DATE: June 6, 2019

SUBJECT: ADDENDUM #2 TO THE BIDDING DOCUMENTS FOR:
BID GROUP #6
MASTER FACILITY PLAN IMPLEMENTATION
COMMUNITY HIGH SCHOOL DISTRICT 99
1436 NORFOLK STREET
DOWNERS GROVE, IL 60516

This addendum forms a part of the Bidding Contract Documents, dated May 10, 2019. Bidders must acknowledge receipt of this Addendum in the space provided on the Bid Form.

Project Number:
5274-42
Drawn By:
J.G.
Sheet:
S2.1B-C1

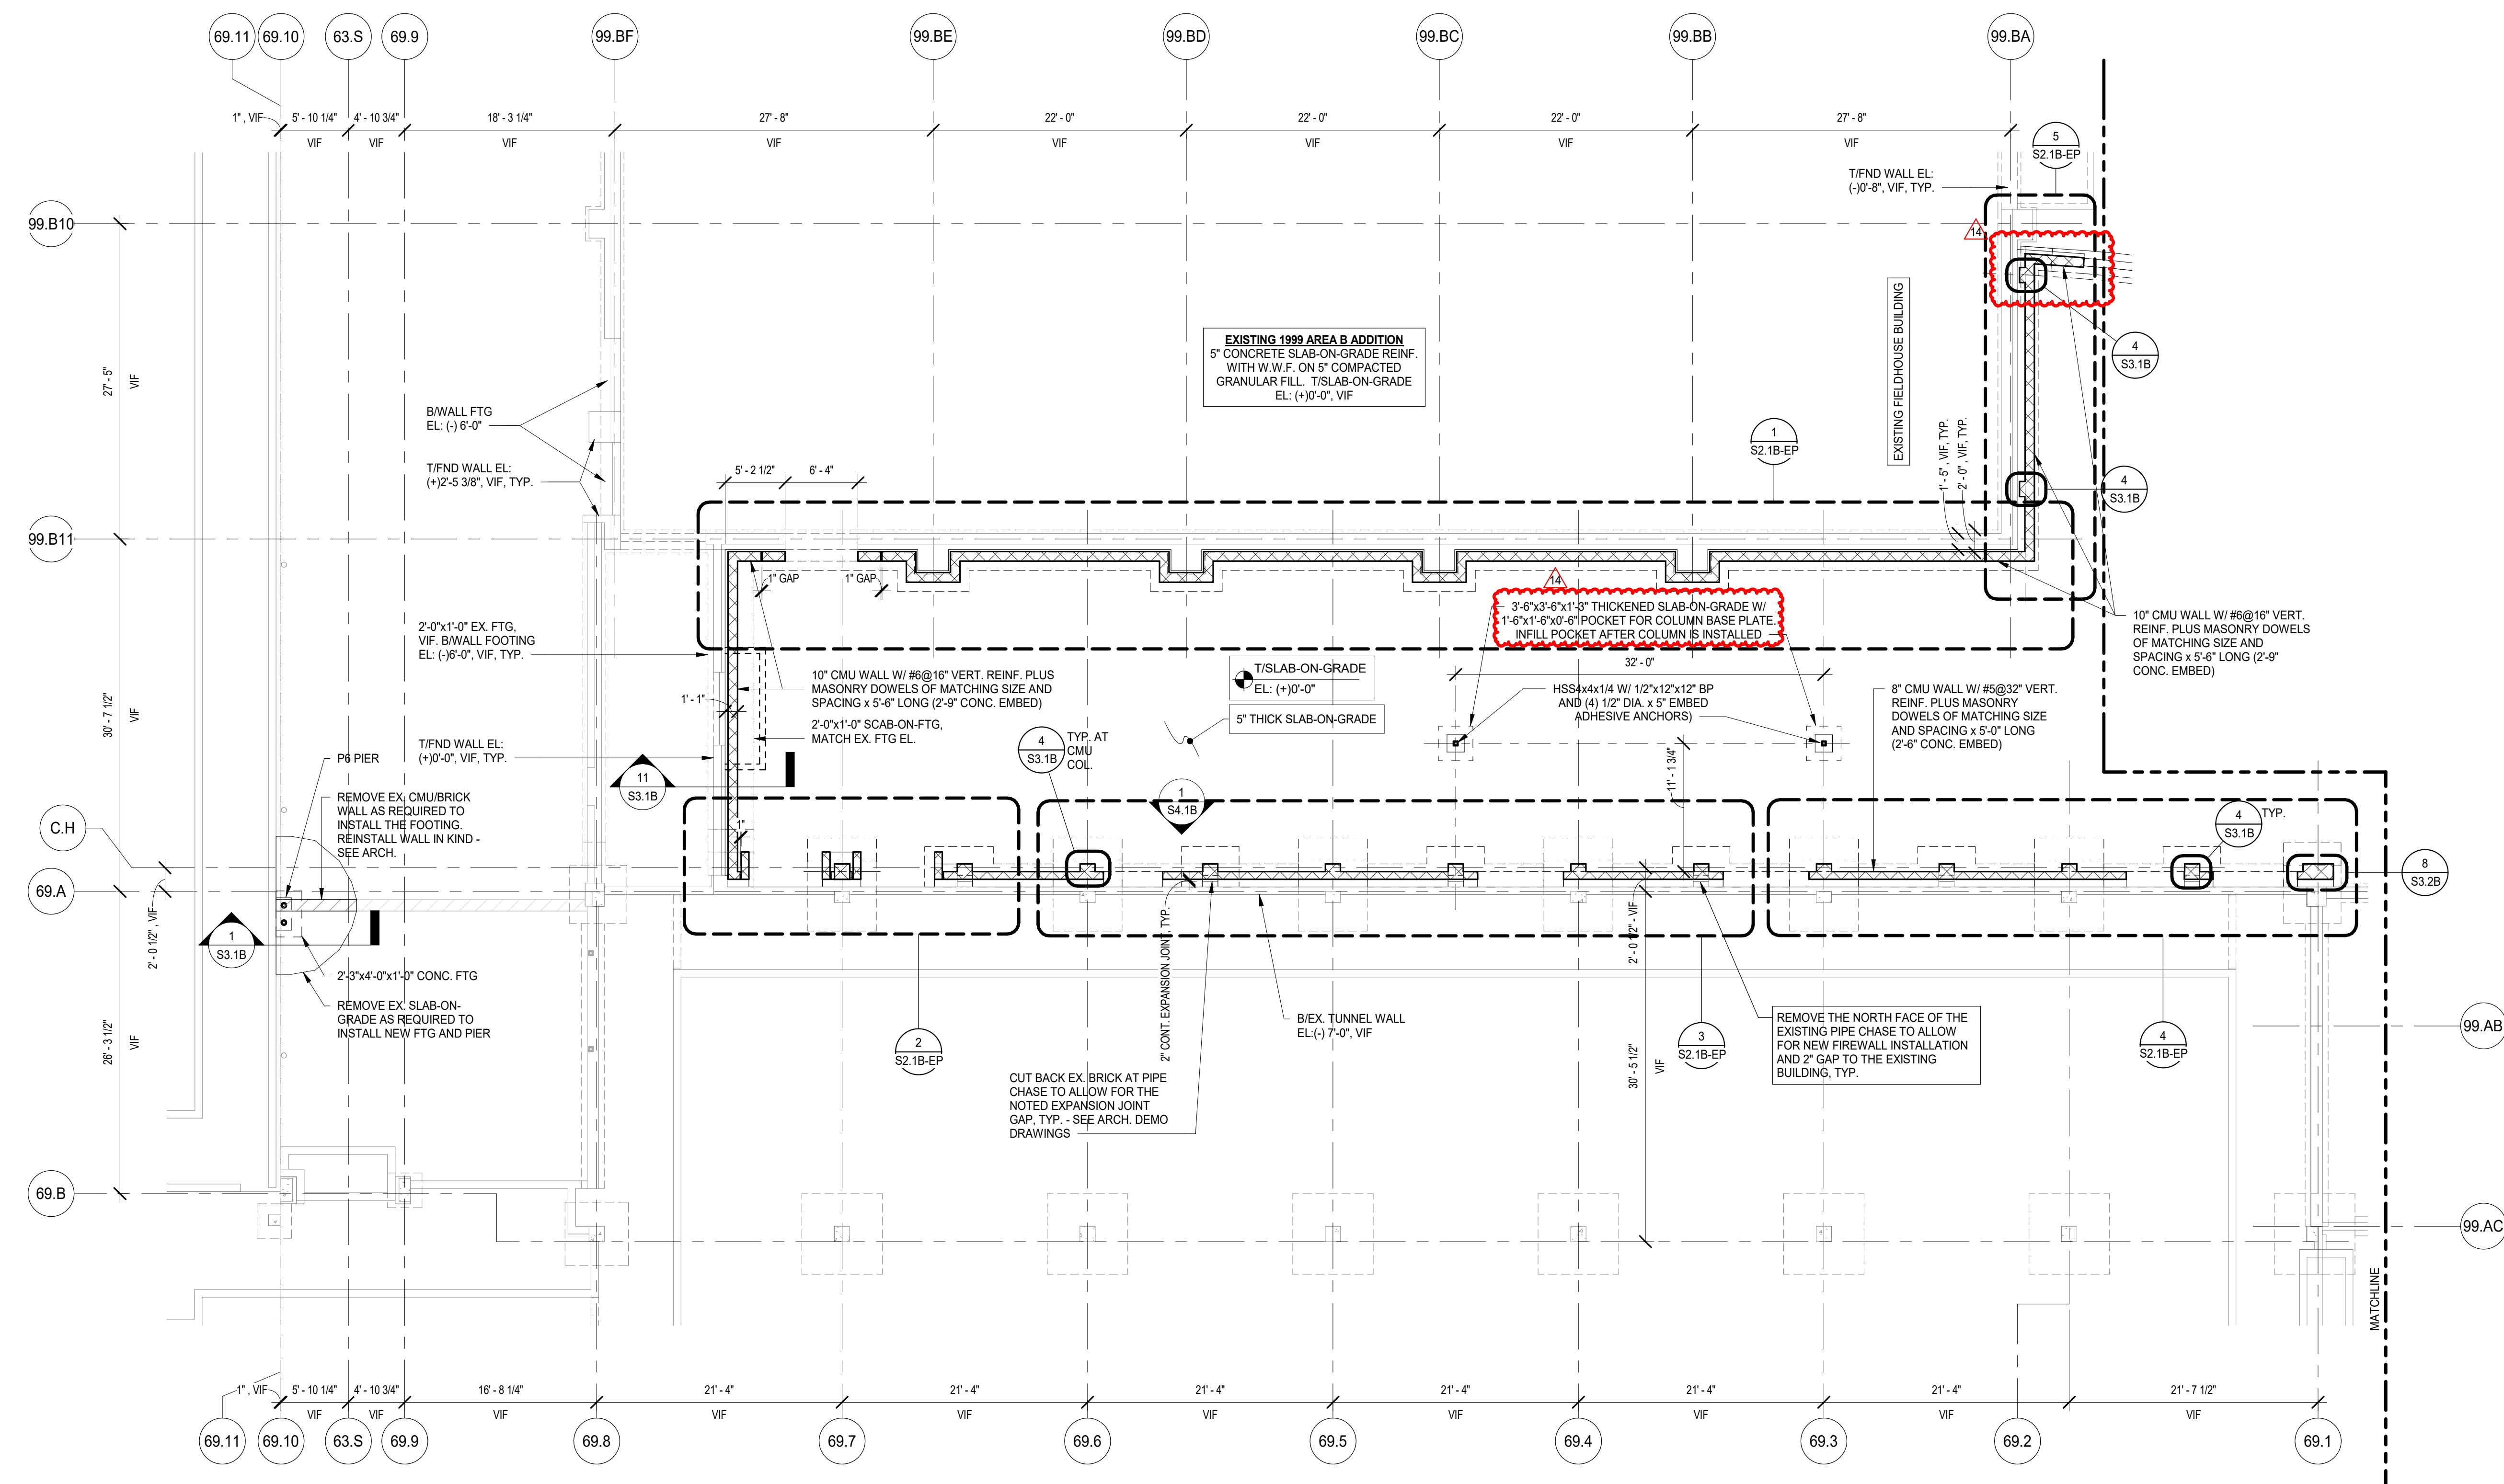
6. Sheet S2.1B-C1 FOUNDATION PLAN -AREA C.1 (**Full size sheet reissued**):
 - a. Fire wall detail at Column Grid 99.B10 & 99.BA modified as clouded.
 - b. Frost stoops added along column line C.B.

NOTE: Frost Stoops are shown on the Structural, Civil, and Architectural drawings but may not be coordinated between them. This TRADE CONTRACTOR shall be responsible for reviewing all drawings and including them where they appear. Refer to Plan Note #21 on sheet S2.1B-C1 for details.

S2.1B-EP

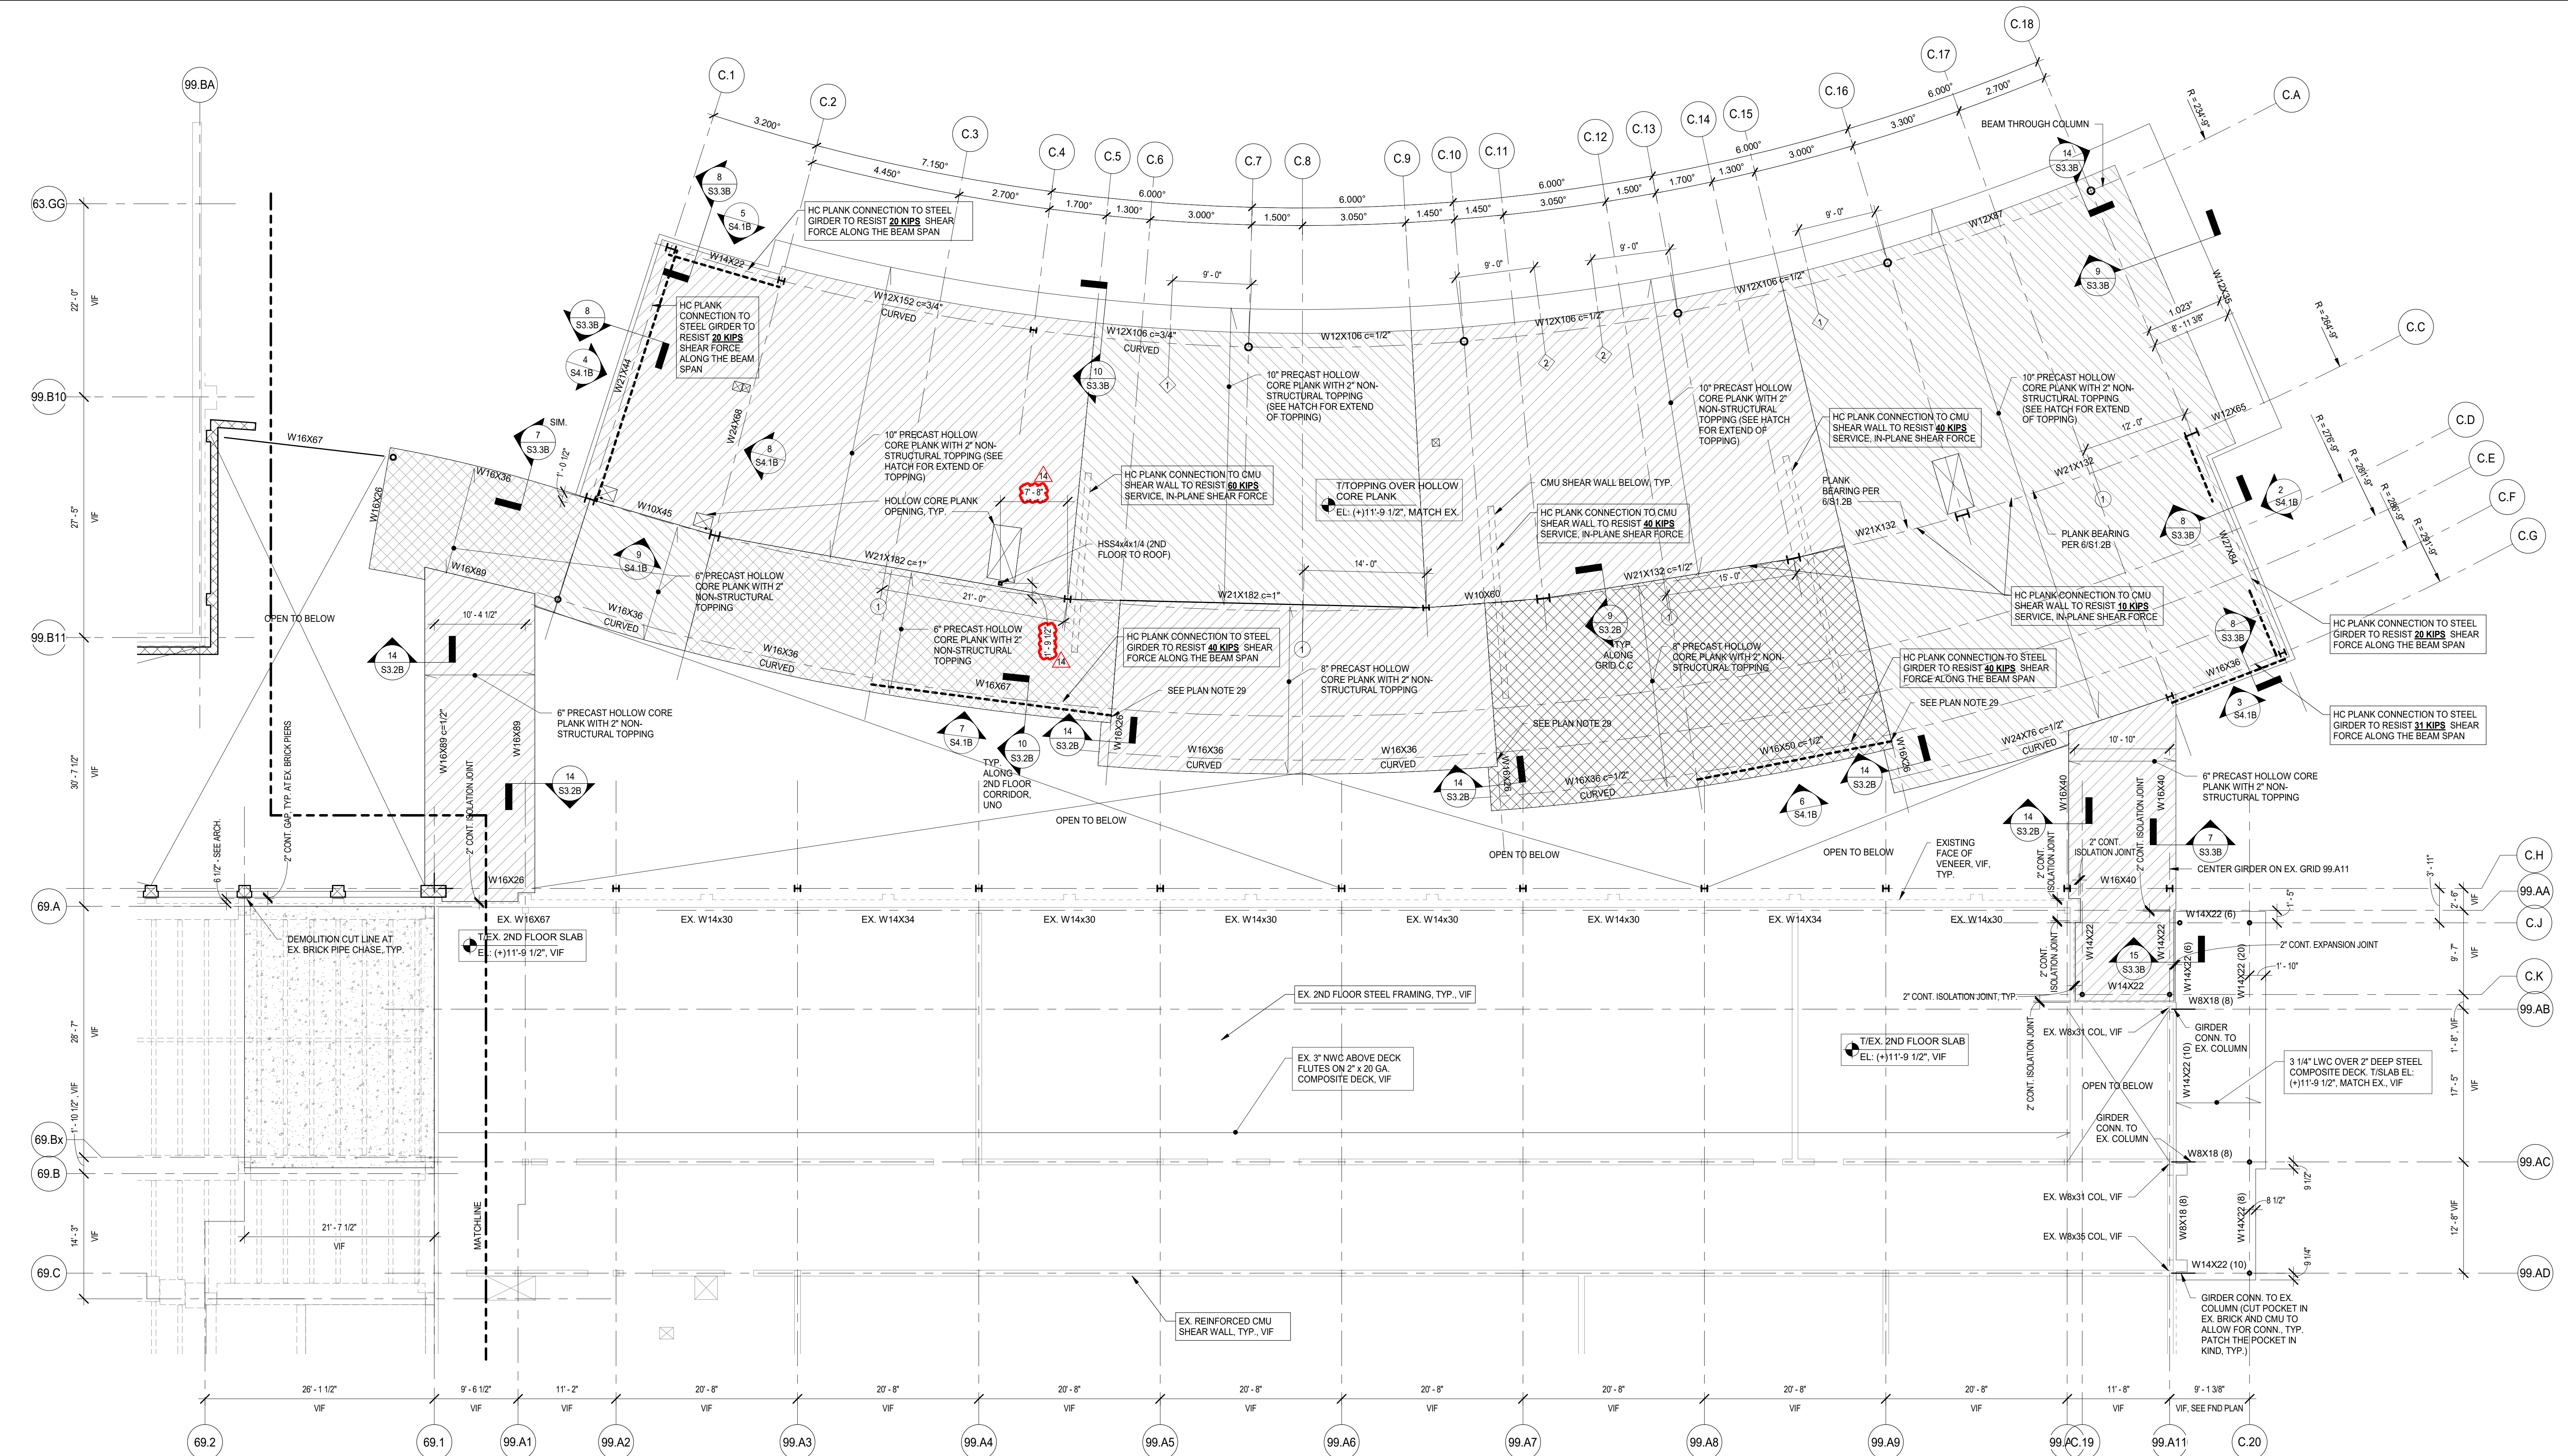
8. Sheet S2.1B-EP ENLARGED FOUNDATION PLANS (**Full size sheet reissued**):
 - a. Foundation plan modified as clouded in detail 5.
9. Sheet S2.2B-C1 2ND FLOOR FRAMING PLAN – AREA C.1 (**Full size sheet reissued**):

S2.2B-C1

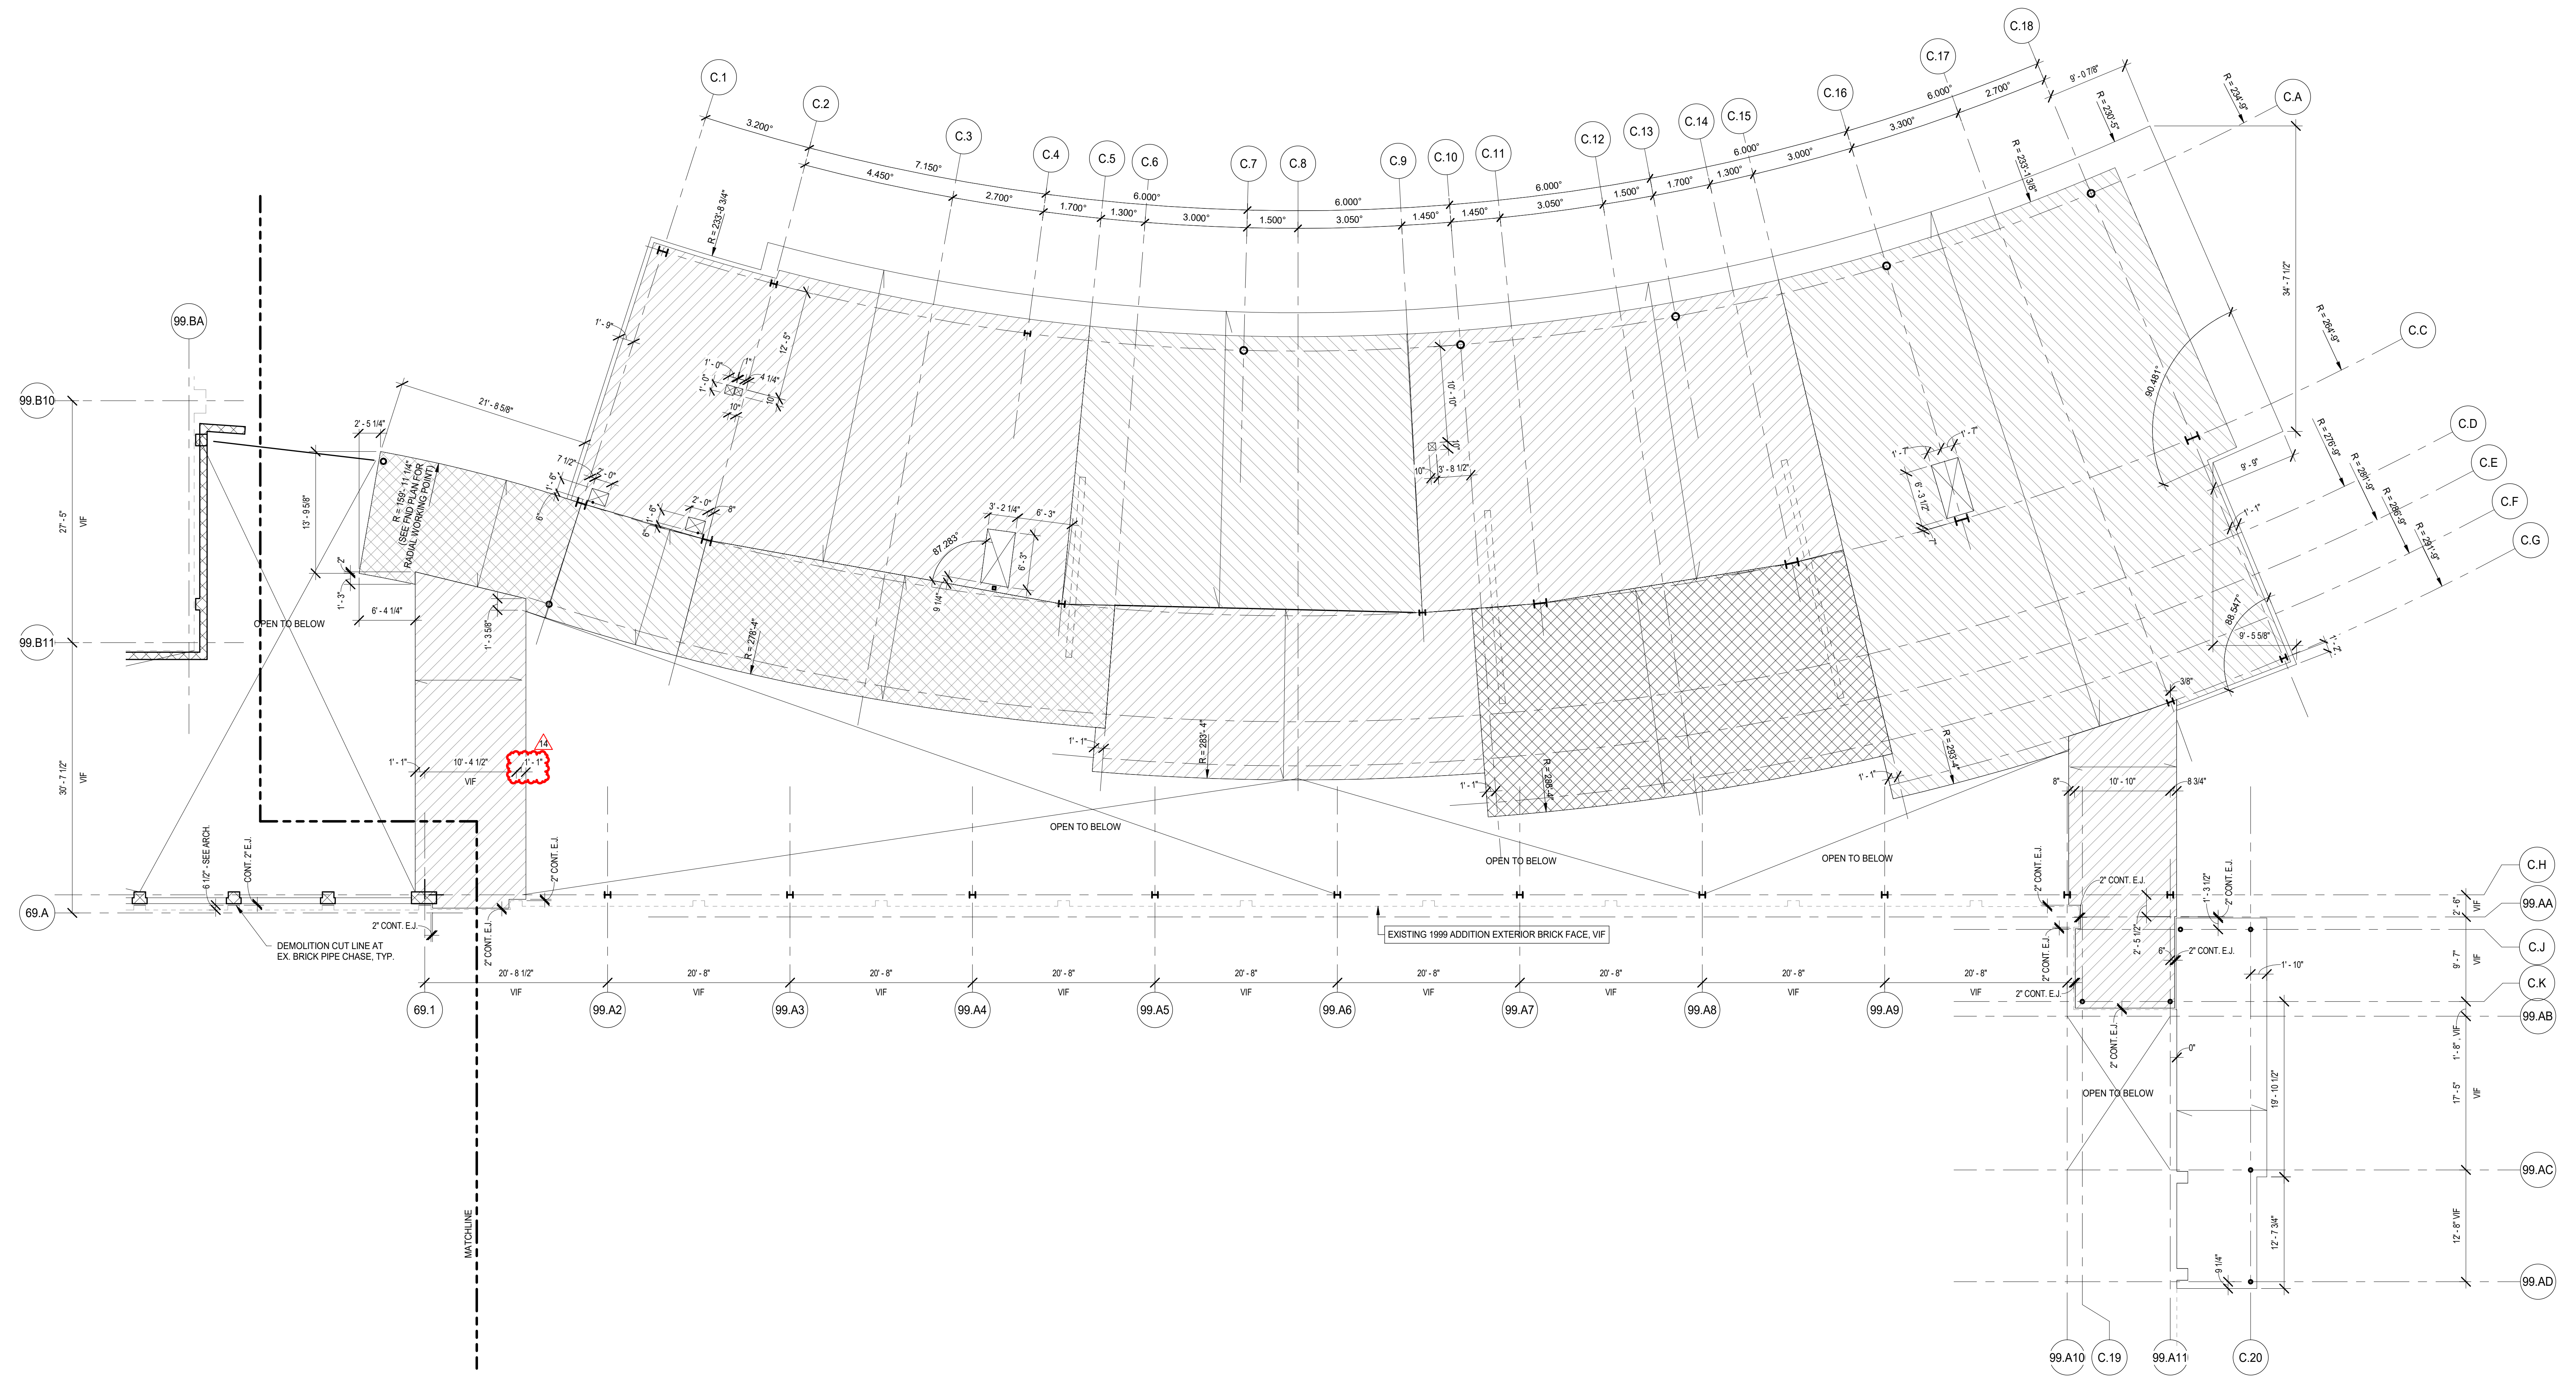
- a. Dimensions provided for HSS at column grid C.4 & C.C.
10. Sheet S2.2B-SE 2ND FLOOR SLAB EDGE PLAN -AREA C.1 (**Full size sheet reissued**):
 - a. Slab edge dimension provided at bridge.
